## COUNCIL ASSESSMENT REPORT

<b>Panel Reference</b>	2016SYE112 DA
<b>DA Number</b>	16/165
<b>LGA</b>	Bayside Council
<b>Proposed Development</b>	Integrated Development Application for the demolition of existing structures and the construction of a five (5) storey mixed commercial and residential apartment building consisting of two (2) levels of basement car parking containing 111 car parking spaces, three (3) ground floor retail spaces and 54 residential apartments across four (4) storeys.
<b>Street Address</b>	19-25 Robey Street and 5 and 5A Elizabeth Avenue, Mascot
<b>Applicant/Owner</b>	Brewster Murray Pty Ltd
<b>Date of DA lodgement</b>	16 September 2016
<b>Number of Submissions</b>	Three (3) submissions
<b>Recommendation</b>	Deferred Commencement consent
<b>Regional Development Criteria (Schedule 4A of the EP&amp;A Act)</b>	Development with a CIV of \$26,379,700.00
<b>List of all relevant s79C(1)(a) matters</b>	<ul style="list-style-type: none"> <li>• <i>Environmental Planning &amp; Assessment Act 1979, Part 4 – Development Assessment &amp; Schedule 4A – Development for which regional panels may be authorised to exercise consent authority functions of councils</i></li> <li>•

**Figure 18: Shadow Diagrams - Mid Winter (Source: Brewster Murray, October 2017)**

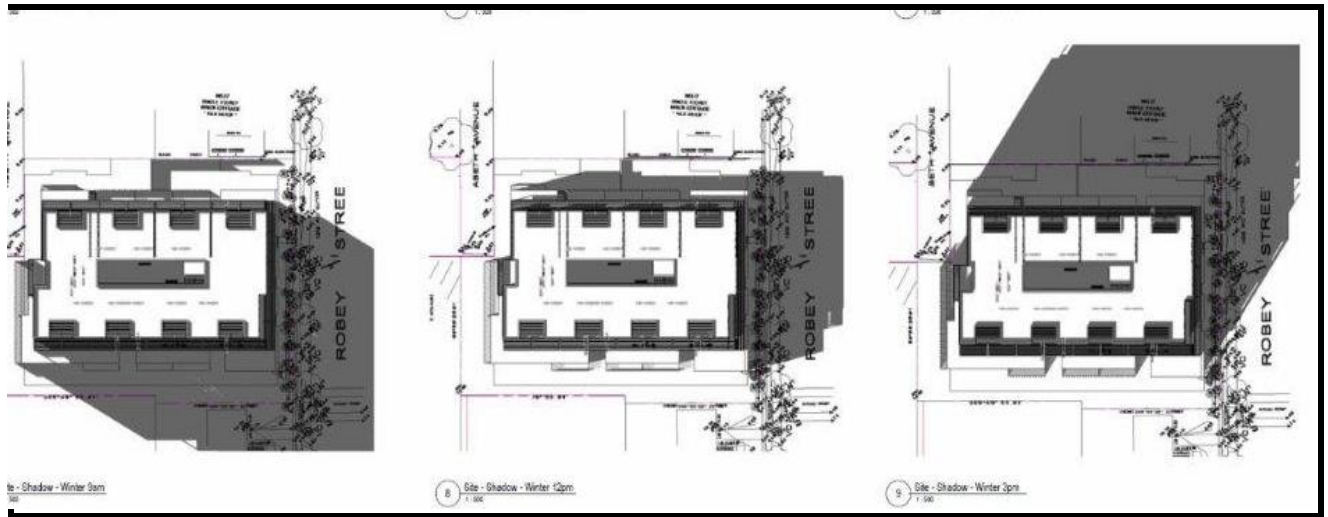
The shadow diagrams provided are illustrated in **Figure 18**. Since the site is orientated north-south, with the southern frontage being to Robey Street, a large proportion of the shadow cast by the proposal falls over the road. While there is shadow cast over the adjoining properties, this shadow moves around such that the adjoining property to the west (No 27-29 Robey Street) achieves the required solar access from midday in mid-winter, while the adjoining property to the east (No 17 Robey Street) receives its required solar access in the morning up until the early afternoon in mid-winter. This ensures the adjoining properties receive the required amount of solar access.

The solar access to both the proposal and the adjoining properties is considered satisfactory in this instance.

**Figure 19: Side and Rear Setbacks - Level 3 (Source: Brewster Murray, Nov 2017)**

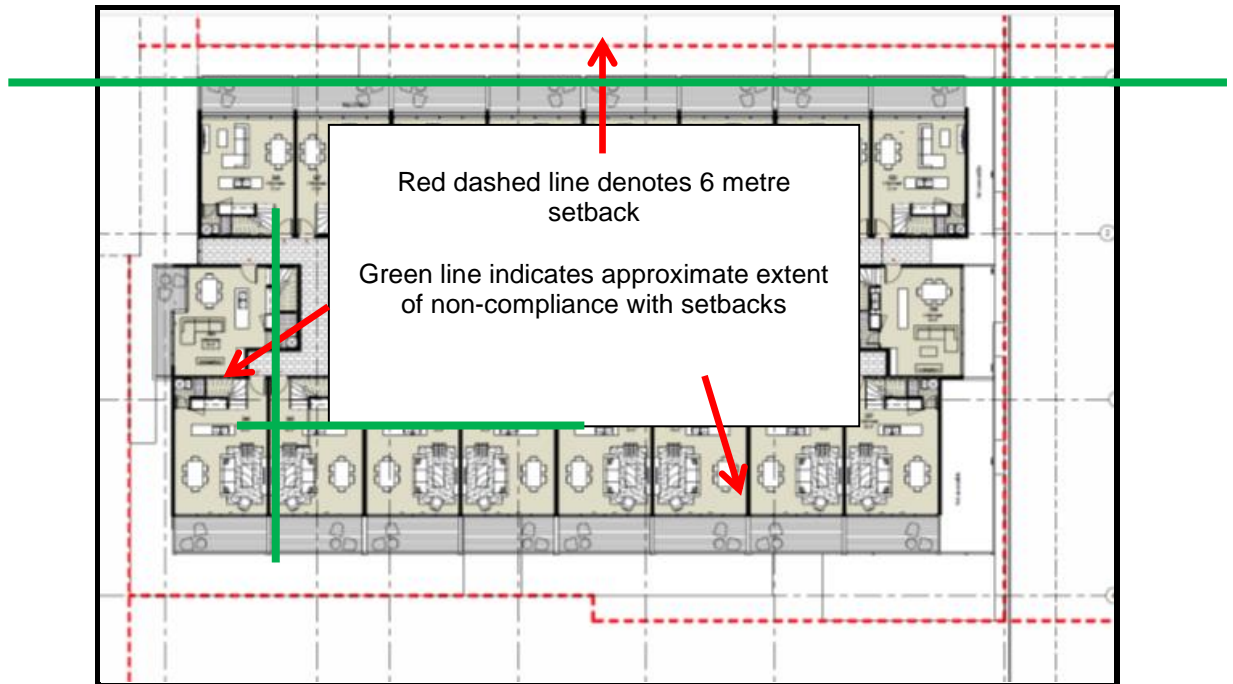
These are restricted to a 0.5 metre wide strip of balcony along the rear portion of the western boundary which adjoins John Curtin reserve, a 1 metre strip of 15 metre building length of a balcony and building (with no windows) to the northern boundary, and a 1 metre strip of balcony along the astern boundary on Level 3. A minor non-compliance on Level 4 consists of a 0.5m encroachment of the building and balcony for a 15 metre length along the northern (rear) boundary.

While the proposal does not strictly satisfy the setback requirements, there are no walls of the building with habitable room windows which directly overlook adjoining developments within these non-compliances. There are portions of balconies in these setback areas, although the balcony on Level 4 in this area is only a secondary balcony to the upper level bedroom levels.

**Figure 21: Proposed Ceiling Heights (Source: Brewster Murray, 3 November 2017)**

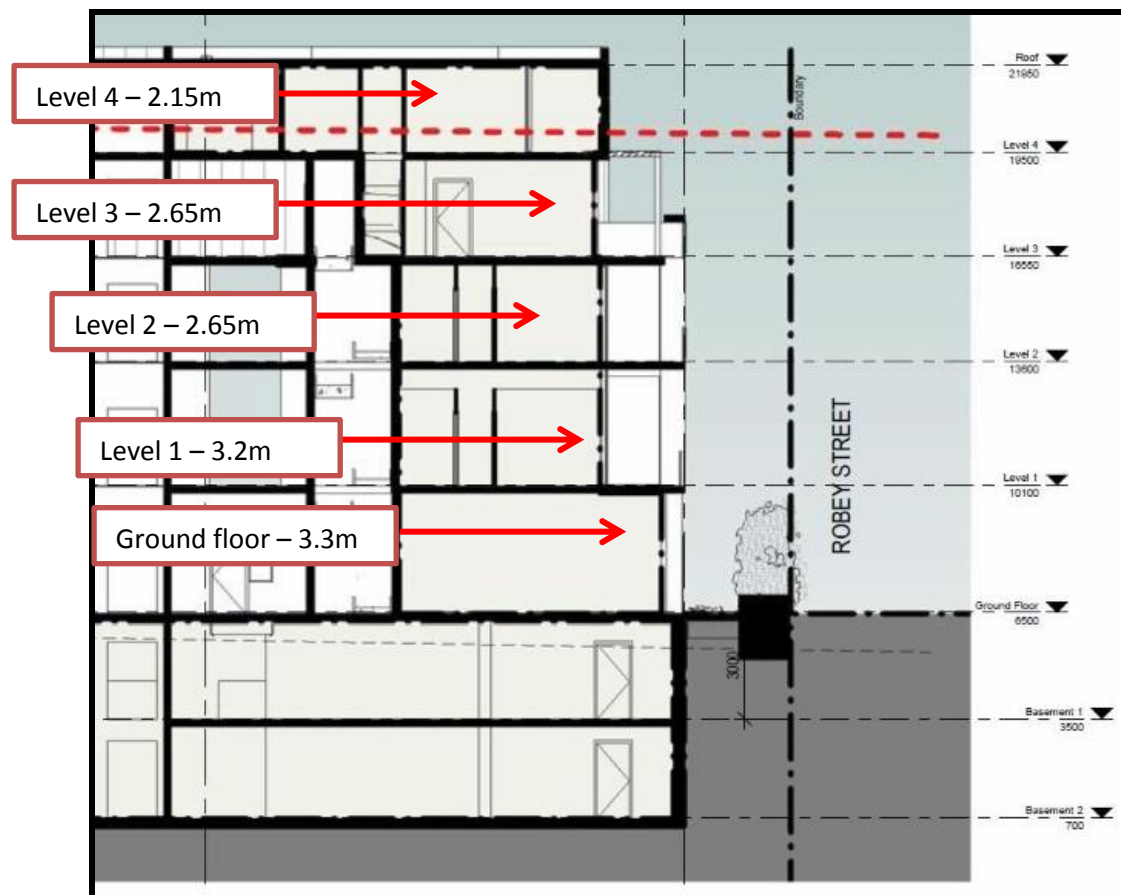
Part 4C of the ADG sets minimum ceiling heights for apartments, which is measured internally from the finished floor level to finished ceiling level. The minimum ceiling heights are outlined in Table 5 and **Figure 21**, along with the proposed ceiling heights for the development. As outlined below, there are numerous non-compliances with the ceiling heights in the proposal.

Type/location of room	Min Ceiling Height (Part 4C of the ADG)	Proposal (to finished ceiling level)	Comply
Habitable rooms	2.7m	Ground – 3.3m Level 1 – 3.2m Level 2 – 2.65m Level 3 – 2.65m Level 4 – 2.15m	Yes Yes <b>No</b> <b>No</b> <b>No</b>
Non-habitable	2.4m	N/A	N/A
For 2 storey apartments	2.7m (main living floor) 2.4m (2nd floor where area<50% of apartment)	Level 3 – 2.65m Level 4 – 2.15m	<b>No</b> <b>No</b>
Attic spaces	1.8m at edge of room (30°min ceiling slope)	N/A	N/A
If located in mixed used areas	3.3m (ground & 1st floor to promote future flexibility of use)	Ground – 3.3m Level 1 – 3.2m	Yes <b>No</b>

While Council acknowledges that the proposed development, as presented in the amended plans, exceeds the development standard by 2.1 metres to the top of the building, this proposed building height results in ceiling heights which are inconsistent with the ADG (refer to Note 3 above).

Taking into consideration the required ceiling heights, the overall height of the proposal would be 16.75 metres, which would provide Levels 2, 3 and 4 with compliant ceiling heights of 2.7 metres. Therefore, for the purposes of this Clause 4.6 assessment, the maximum overall height of the proposal is considered to be 16.75 metres and not 16.1 metres as outlined in the applicant's Clause 4.6 request.

It is recommended that the proposal is supported in a deferred commencement consent to allow for amendments to be made to comply with the ceiling height controls of the ADG. If this recommendation is supported by the SCPP, a revised Clause 4.6 request would be required if the overall height of a future amended proposal exceeded the maximum height limit of 14 metres.

**Figure 25: Street Wall Height diagrams (Figure 26 from Part of Source: BBDCP 2013)**

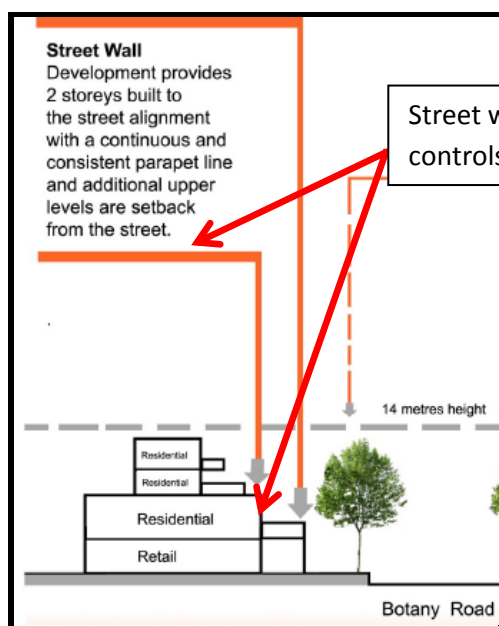
Parts 5.2.2.8 (Mascot Local Centre - Botany Road (C4) and 5.3.1.3 of BBDCP 2013 require that buildings are aligned along the street frontage to create a consistent street wall no higher than two storeys. The controls also state that a variation to the two storey wall height along the street frontage will only be permitted in certain circumstances where the height of adjoining buildings on the street exceeds two storeys or where the site is located on a street corner. Figure 26 in Part 5.2.2.8 of BBDCP 2013, illustrated below, demonstrates the need for a two storey street wall height.

The proposal involves a street wall height of three (3) storeys (refer to **Figures 25** and **26** above), which includes the ground floor commercial development and Levels 1 and 2 of the proposed residential apartments. While this exceeds the controls, it is consistent with the approved development adjoining to the west at 27-29 Robey Street (**Figure 27**).
